**Comanche Peak Nuclear Power Plant, Units 3 & 4  
COL Application**

**FSAR Revision 3**

**Update Tracking Report**

**Revision 4**

Figure 8.1-1R Simplified One Line Diagram Electric Power System

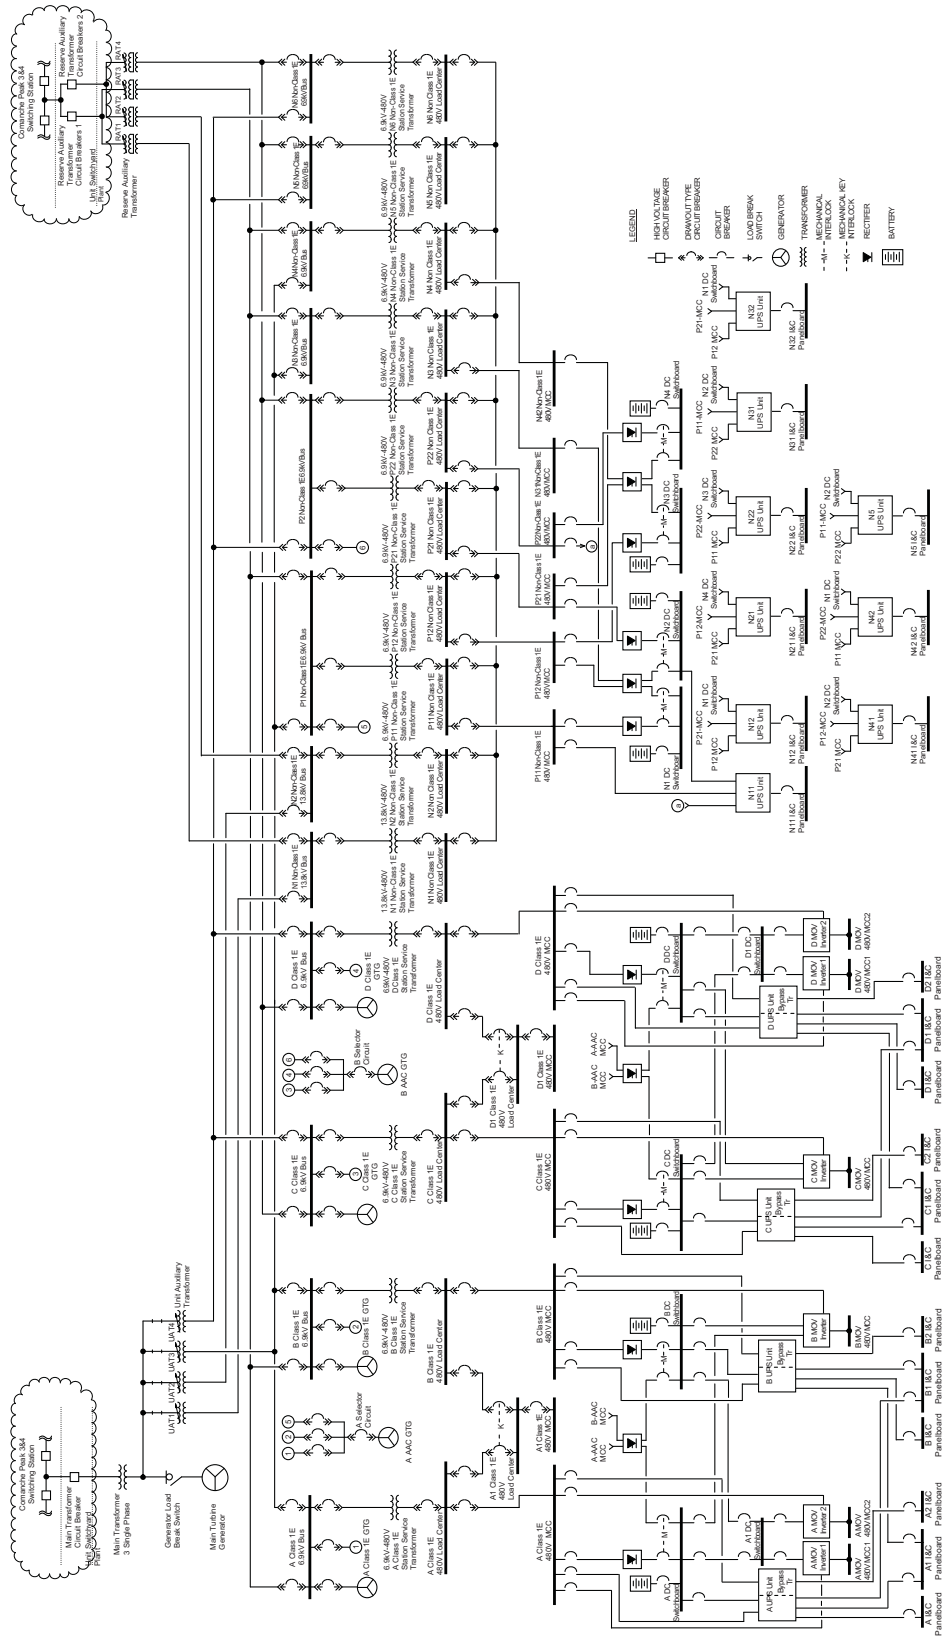
Change ID No.	Section	FSAR Rev. 3 Page	Reason for change	Change Summary	Rev. of FSAR T/R
CTS-01566	Figure 8.1-1R	8.1-2 [8.1-3]	Consistency with DCD Rev. 4	One Line Diagram is revised.	4
CTS-01566	8.3.2.1.1	8.3-2	Consistency with DCD Rev. 4	Changed the numbering of the paragraph from "third" paragraph to the "fifth" paragraph.	4
CTS-01566	Figure 8.3.1-1R (Sheet 1 of 7[8])	8.3-10	Consistency with DCD Rev. 4	One Line Diagram is revised.	4
CTS-01566	Figure 8.3.1-2R (Sheets 18 through 21 of 24)	8.3-17 through 8.3-20	Consistency with DCD Rev. 4	Logic Diagram is revised.	4
CTS-01566	8.4	8.4-1	Consistency with DCD Rev. 4	Changed the numbering of the paragraph from "ninth" paragraph to the "tenth" paragraph.	4

Figure 8.3-1-1R Onsite AC Electrical Distribution System (Sheet 1 of 78)  
 Main One Line Diagram

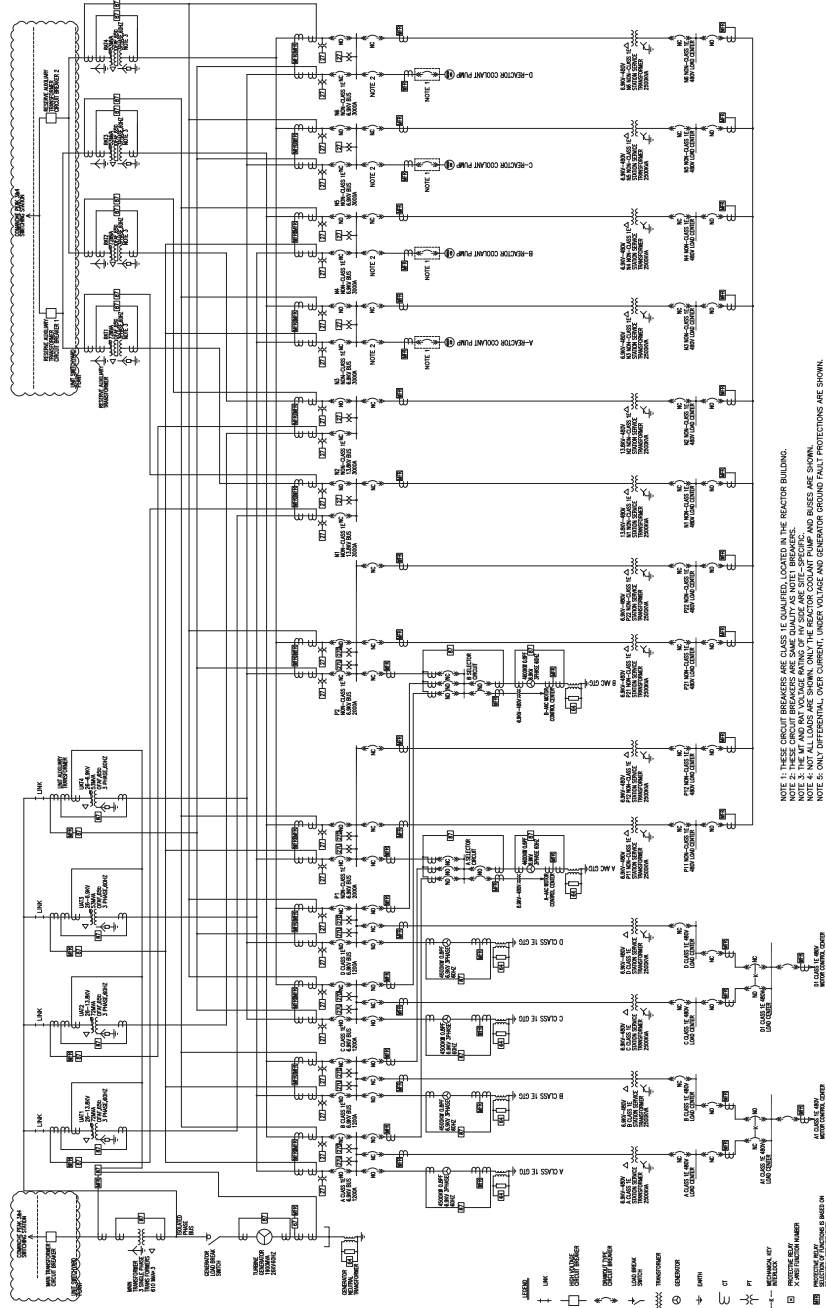
CTS-01532  
 CTS-01566

Figure 11.2-201 Liquid Waste Management System Piping and Instrumentation Diagram (Sheet 3 of 10)

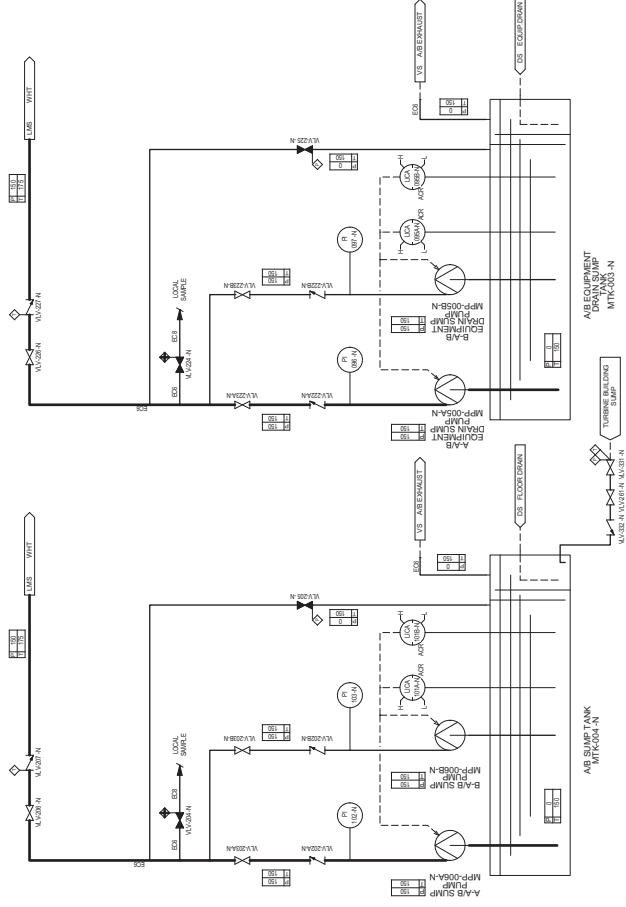
CTS-01569	Figure 11.2-201 (Sheet 3 of 10)	11.2-26	For consistency with DCD Rev.4 and editorial correction.	Changed the description of Non-radioactive drain sump to reflect the DCD changes.  Made editorial corrections on the piping line.	4
